Request for Further Information - DA2 Mod 12 and DA3 2 Mod 10 Penrith Lakes

This letter provides a response to the Department of Planning, Housing and Infrastructure's (DPHI) Request for Further Information, dated 16 April 2025, in relation to the Penrith Lakes Scheme (DA2-Mod-12 and DA3-Mod-10). Specifically, it addresses the matters set out in Attachment A, Points 1 to 4, which seek clarification on the following:

Figure 1: 1:20 slope option

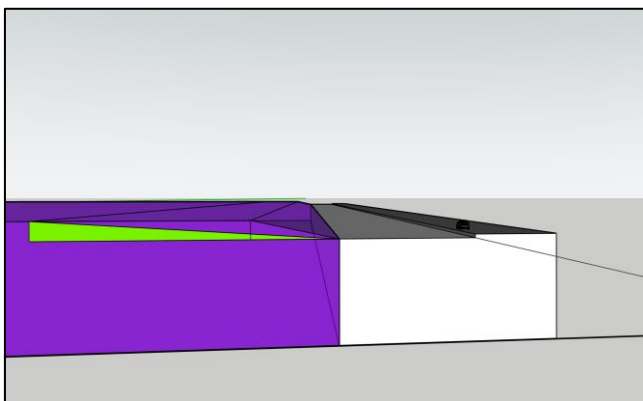
Information that describes how you propose to mitigate anticipated visual impacts. The Visual Impact Assessment (VIA) concludes that there will be some impacts. The impacts of most concern are those that have been identified as moderate impacts in the VIA. These relate to one landscape character zone called 'LCZ 2 - Nepean River and floodplain' and one viewpoint called 'Viewpoint 2 - Castlereagh Road (north)'.

Please advise what measures you are proposing to mitigate the impacts and what this means for the overall quantity and locations of fill you are seeking to place on the site.

Alterations to batter gradient: Figure 1 below shows a 1:20 batter gradient in green facing Castlereagh Road compared to the original 1:6 gradient included in the modification application as shown in purple..

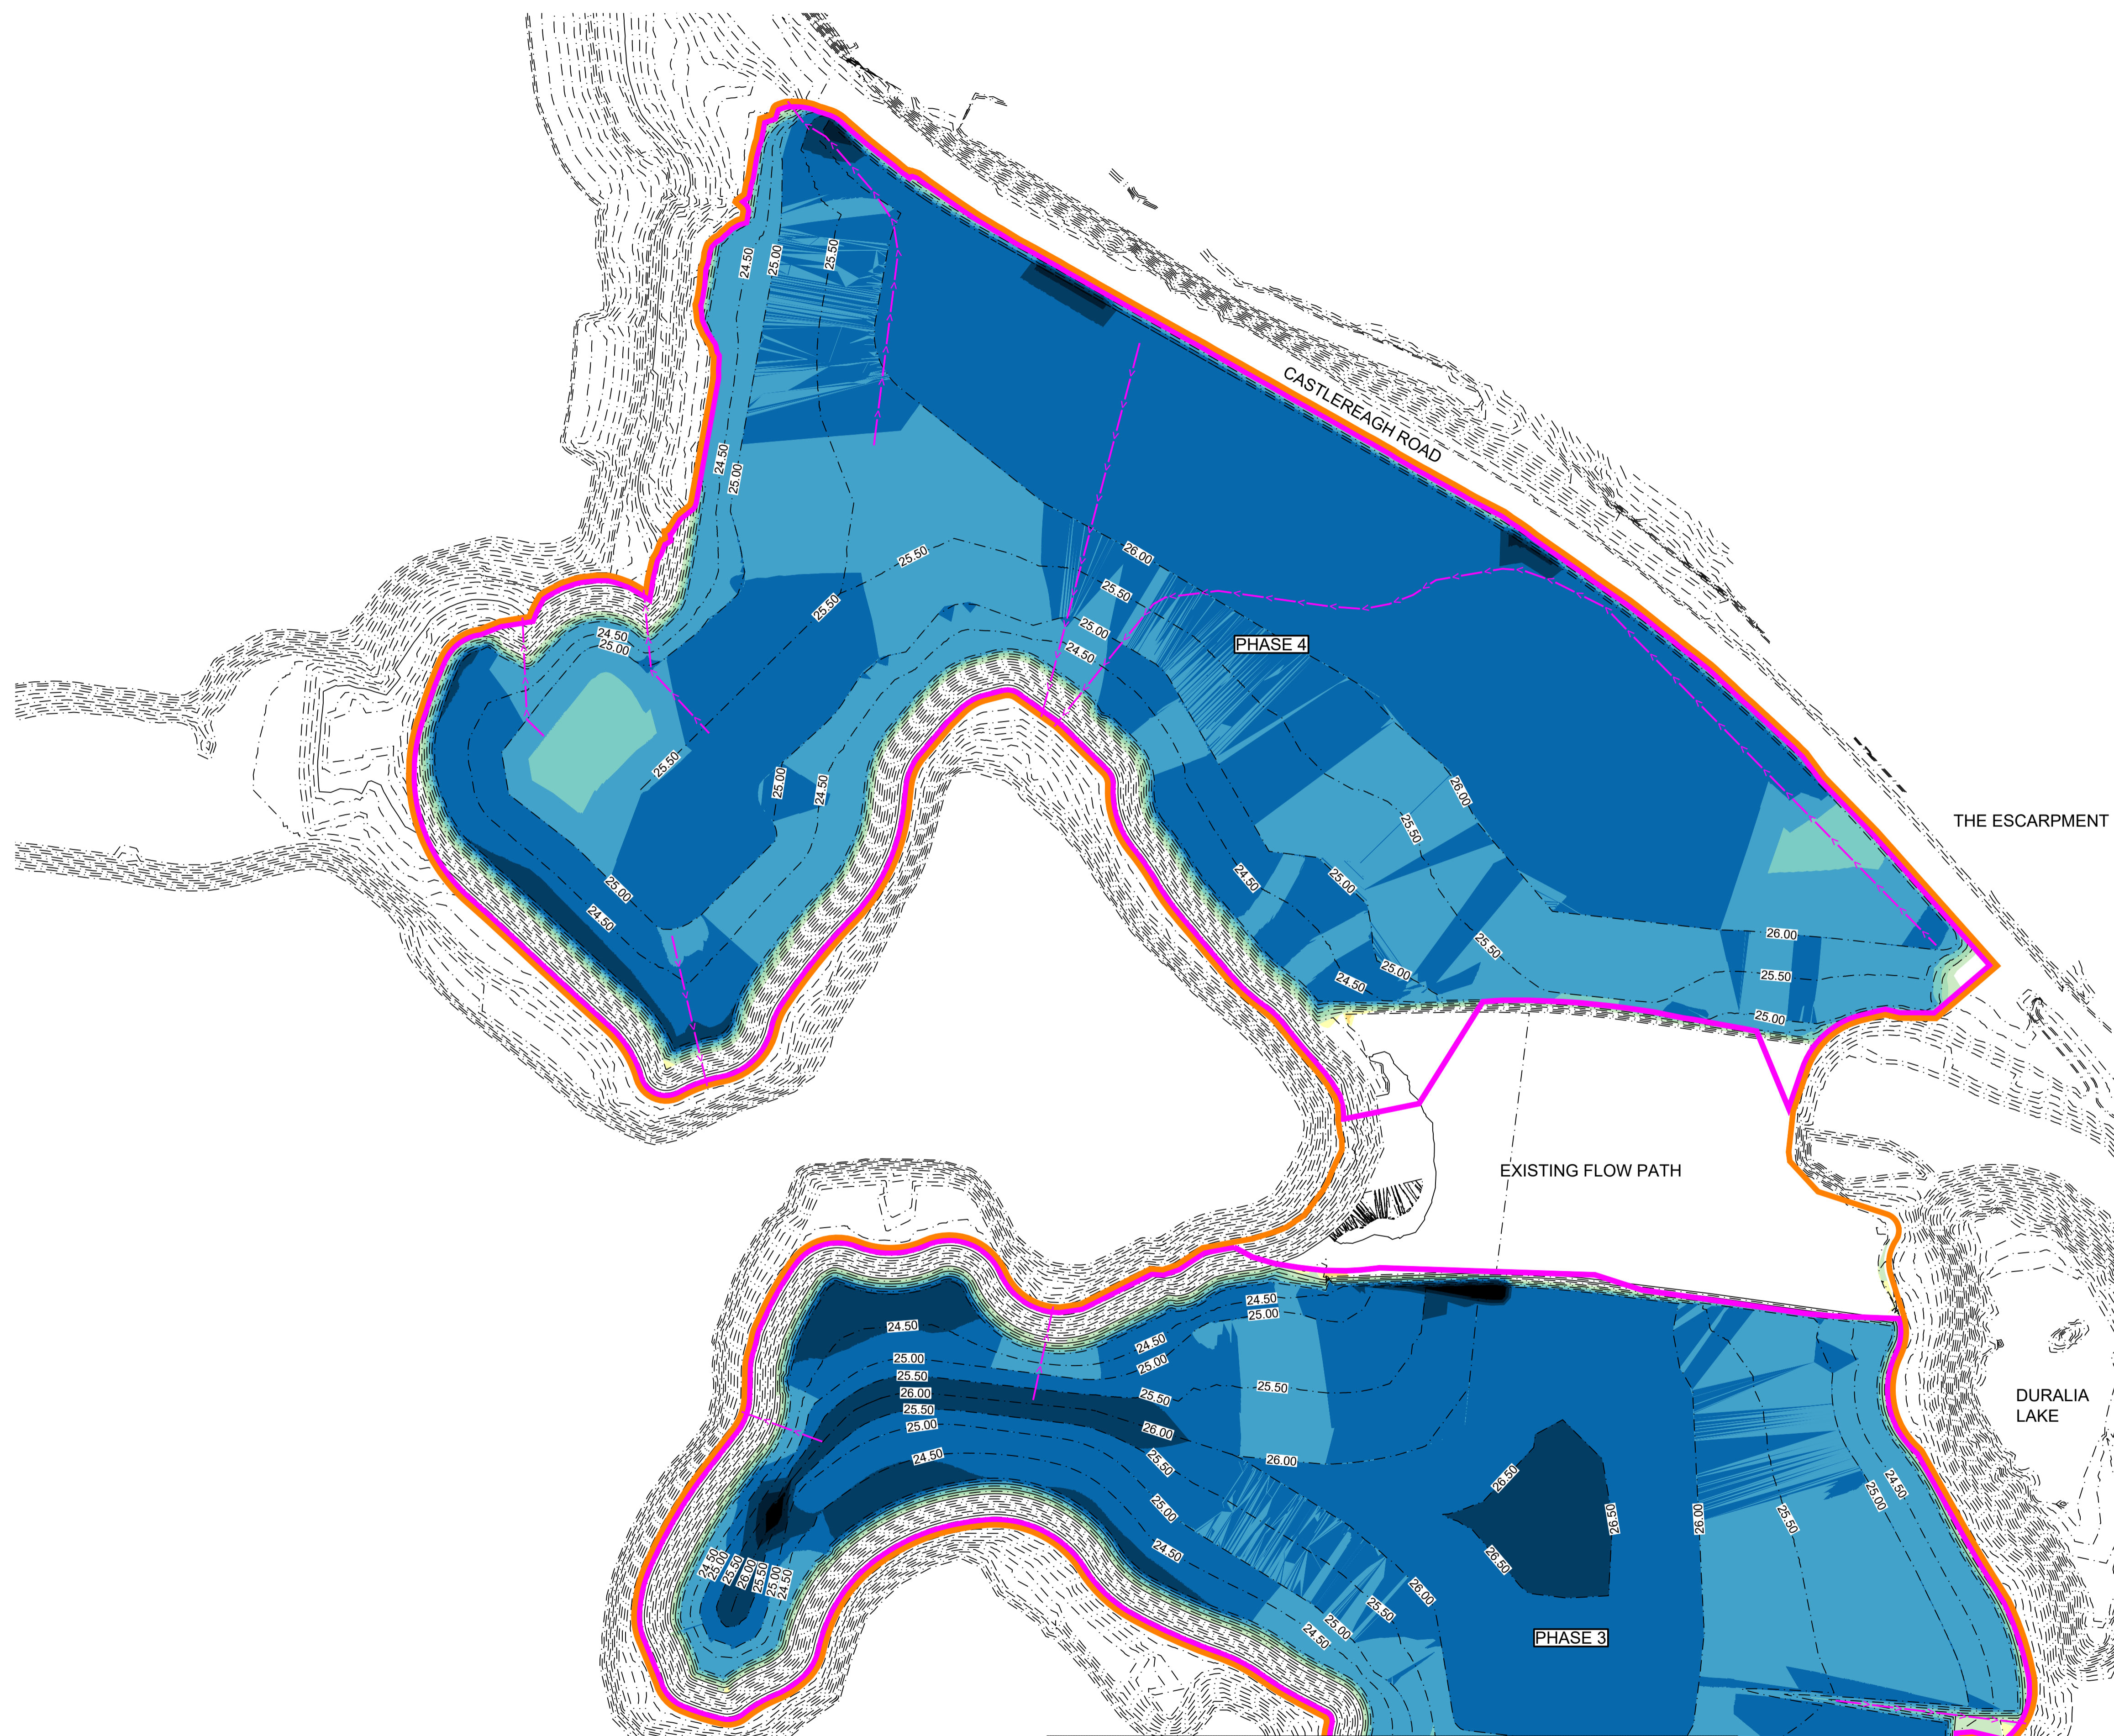
A bulk earthworks plan, provided in a format that assists with understanding the depth of fill proposed to be placed across the site (for example, a contour plan and/or heat map).

- *Southern and central areas (SK212)*: Ground levels will rise by 0–1.5 m across most areas, with some isolated increases up to 2.5 m.
- *Northern area (SK213)*: Ground levels will rise by 1–2.5 m across most areas, with some spots increasing up to 3 m.
